RE: St. Lucie Units 1 and 2
Docket Nos. 50-335 and 50-389
Response to NRC Request for Additional Information
Generic Letter 96-06 Waterhammer Issues

Attachment
St. Lucie Units 1 and 2 Response
NRC Request for Additional Information Dated August 1, 2003
Regarding GL 96-06 Waterhammer Issues

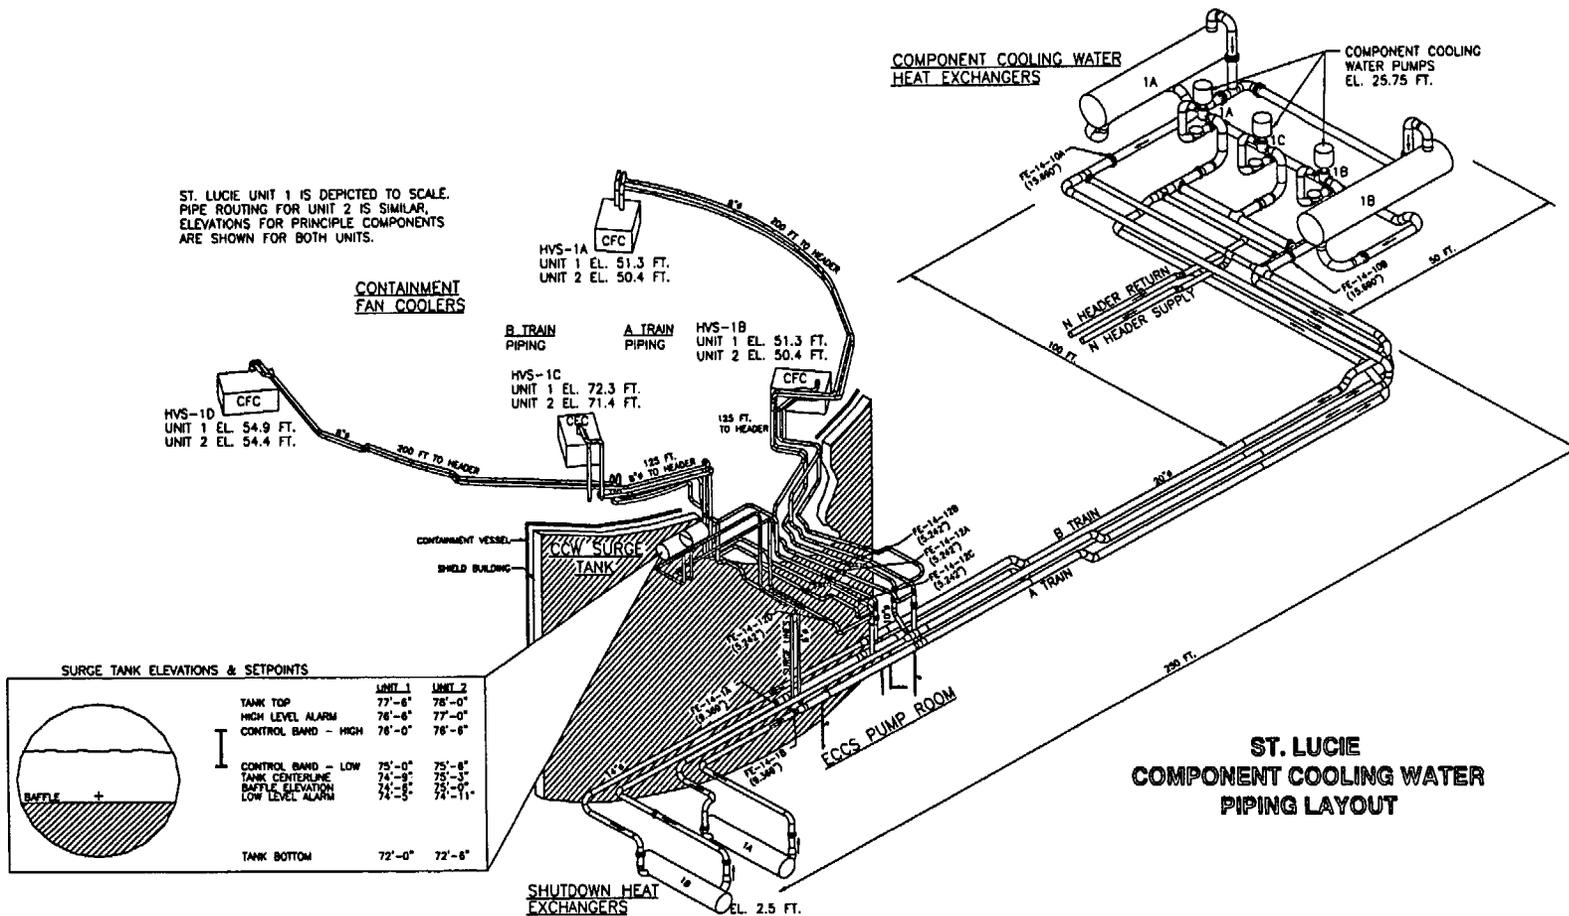
NRC Question 1 - Page 2 of the March 13, 2003, submittal discussed benchmark testing of Component Cooling Water (CCW) system pump coastdown and recovery following restart. Provide a comparison between these tests to a postulated loss of offsite power (LOOP) event at St. Lucie. Provide comparisons of steam formation within the CCW piping, number of pumps starting, maximum flow rates within the system after pump restart and waterhammer produced. Also, identify the location of the test section, discussed on page 3, relative to the CCW pumps and the containment coolers.

Information concerning the number of pumps starting in the benchmark test and LOOP-only scenario, and maximum flow rates expected within the system after pump restart is provided as follows:

Parameter	Test Condition	LOOP Only Condition
Number of Pumps Starting	1 (half system w/SDC Hx)	2 (N-header not isolated)
Maximum flow rates	~7640 gpm per pump	~5700 gpm per pump
Flow rate at the CFC	~1350 gpm	~1400 gpm

Benchmark test measurements were taken at pipe penetrations adjacent to the outside containment shield building wall. Relative locations to system components are shown on the following figure.

FIG. 1. HYTRAN MODEL OF LOOP B PIPING - SCHEMATIC

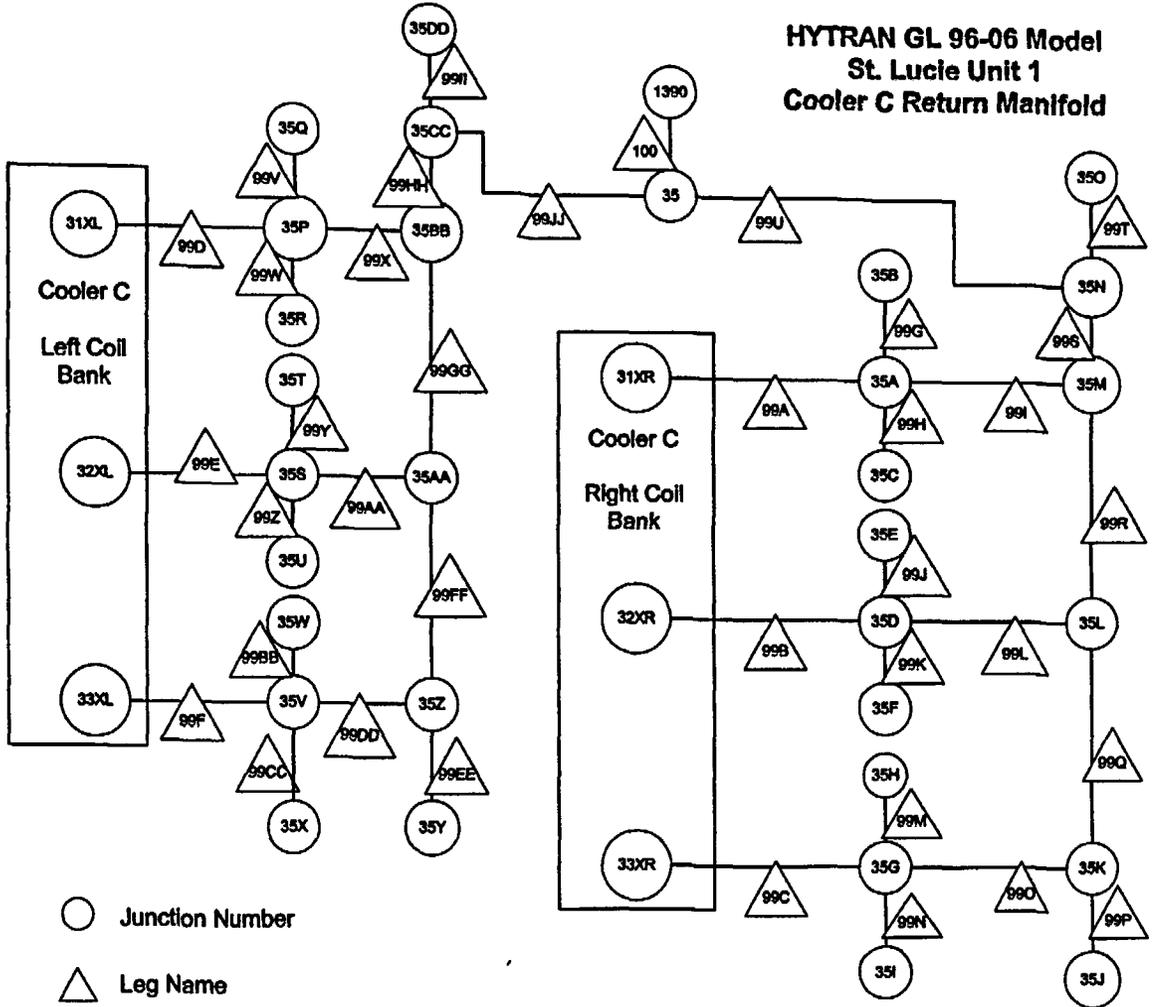
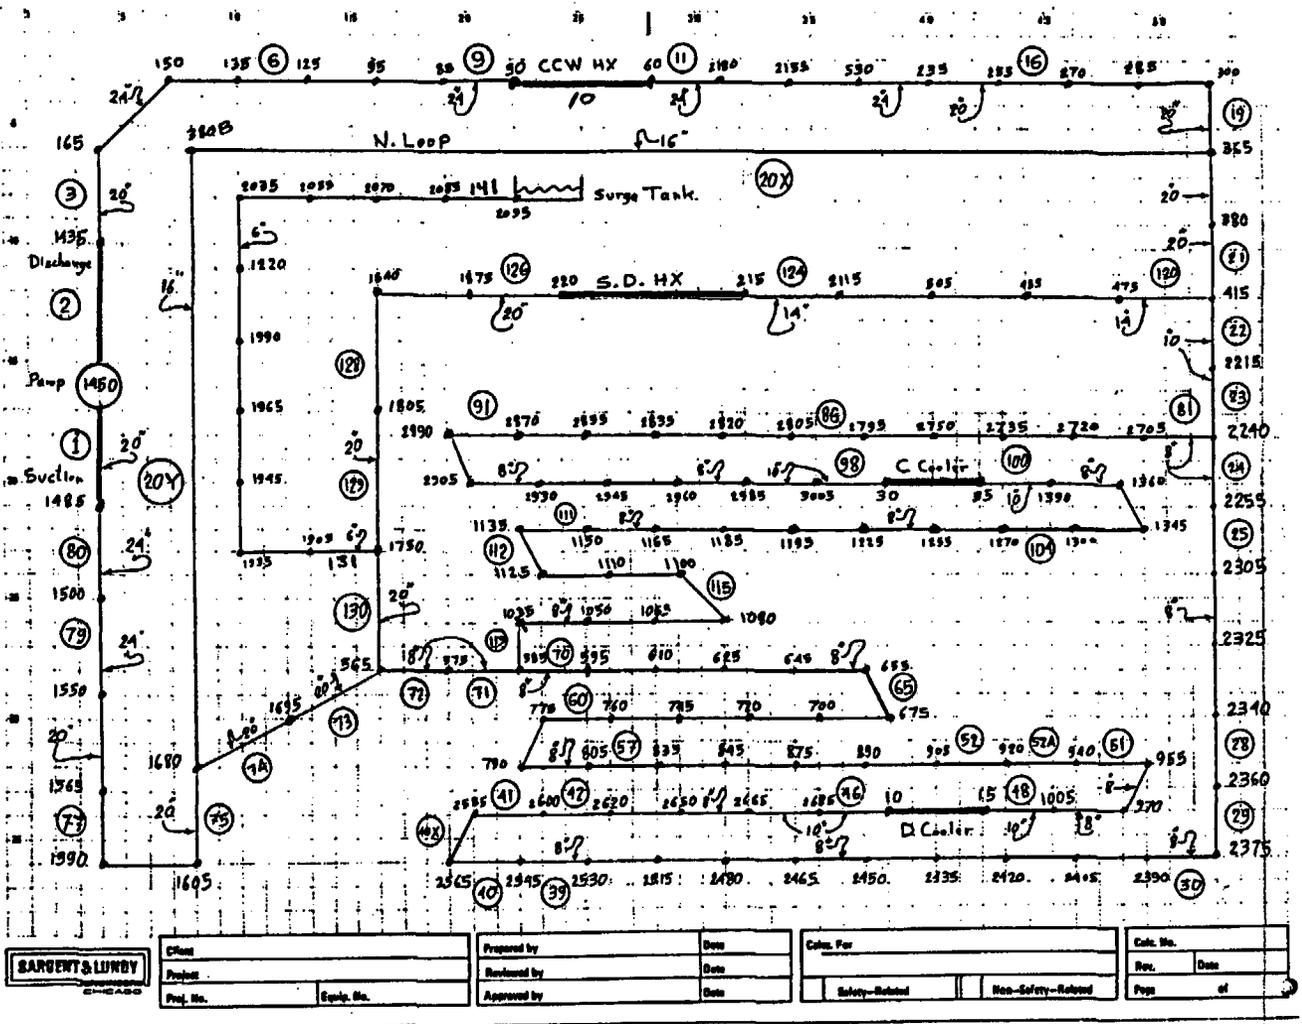
NRC Question 3- The submittal states that the HYTRAN code was used to predict peak pressure produced in the waterhammer analysis. The NRC staff has not previously reviewed the HYTRAN code for waterhammer analysis within CCW piping. Provide either the HYTRAN code for staff review, or provide an analysis of the most severe waterhammer postulated within the CCW piping using the Electric Power Research Institute (EPRI) methodology that the staff has approved. If you choose to apply the EPRI methodology rather than submitting the HYTRAN code for staff review, provide the following information:

The following Load Comparison Table compares RBM and HYTRAN/MOC maximum leg forces. The accompanying Node Point/Leg Sketches indicate the locations of the legs.

Maximum Forces at 45 Pipe Legs for Various Void Sizes

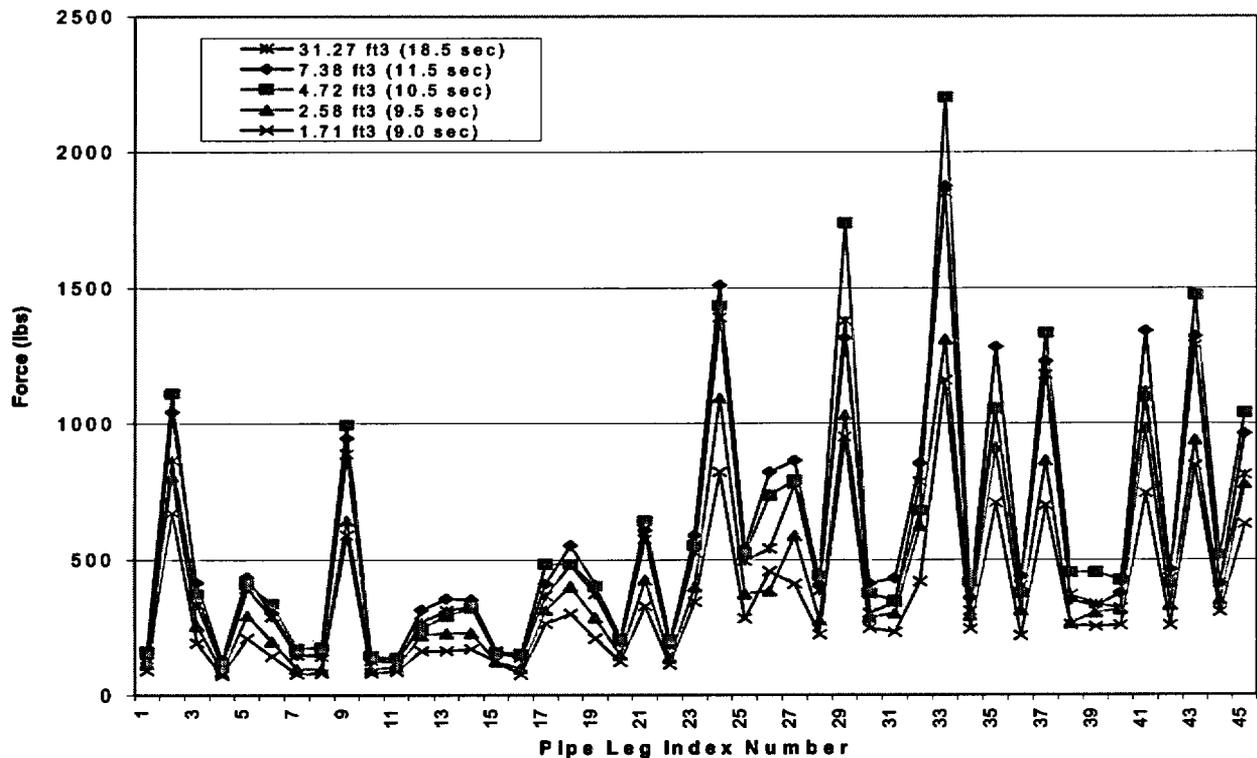
NRC Question 8 - Page 11 of the submittal states that the loads and stresses are "not sensitive to void size." Explain.

For St. Lucie, the combination of these two effects limits the variance in the column closure velocity with void size and hence limits the variance in waterhammer forces with void size.

A parametric review was performed with respect to the affect of void size on maximum pipe segment loads for the 45 legs in the CFC return lines within the Unit 1 B CCW train for five arbitrary void volumes. The effect of void size on pipe segment loads is shown below. The results indicated that the loads were very small at low void size (1.71 ft³), increased as void size increased (2.58 ft³ to 4.72 ft³), decreased slightly at 7.38 ft³ and dropped off again at a void size of 31.37 ft³. The variance in the maximum loads between the analyzed case (7.38 ft³) and other void sizes reviewed ranged from 10% to 25%.
